County of Humboldt Extraction Review Team 2024 Post-Extraction Report

County of Humboldt Extraction Review Team (CHERT)
Geoff Hales, PG, John Bair, Randy Klein, Dr. Andre Lehre, and Dr. Andrew Stubblefield

Final Report

June 6, 2025

Figure 1. Van Duzen River Ranch Trench A location, shown by orange arrow. Proposed excavation limits are shown by the black outline, actual extraction limits are shown by the yellow outline. Van Duzen River flow direction is from right to left.

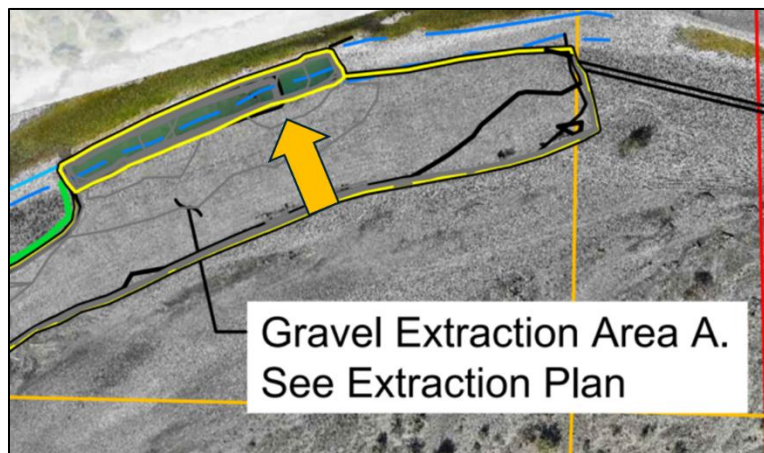
- Van Duzen River Ranch, Area A (115%). This was a wide shoreline skim abutting a trench. In the post-extraction narrative, the operator does not address why the overextraction occurred. 24,070 cu yds were proposed (and approved) for removal, 27,660 cu yds were removed. In the post extraction report, several of the cross-section surveys indicate that while the skim floor was sloped towards the river, as specified for drainage, it extended below the proposed elevation and below the 35% exceedance flow elevation. CHERT considers this exceedance to be an unreasonable deviation from the approved plan as this action creates a significant likelihood of causing a shift in the river channel. Additionally, we note that both trenches were under-excavated, in some cases only reaching half the specified depths. However, they appear to be approximately 6 feet deep, which is sufficient to be effective in creating pool habitat for aquatic organisms. The overall site did not exceed approved volumes. We also note that a request from the operator (9/6/2024) to extend Trench A abutting this skim was not approved, yet the trench length appears to have been extended anyways (Figure 1). The operator suggests that someone moved the survey stakes. The additional extracted length puts the upstream end of the trench closer to the channel riffle. Riffles are purposefully avoided in excavation site approvals, as the trench could destabilize the riffle and impair fish passage.
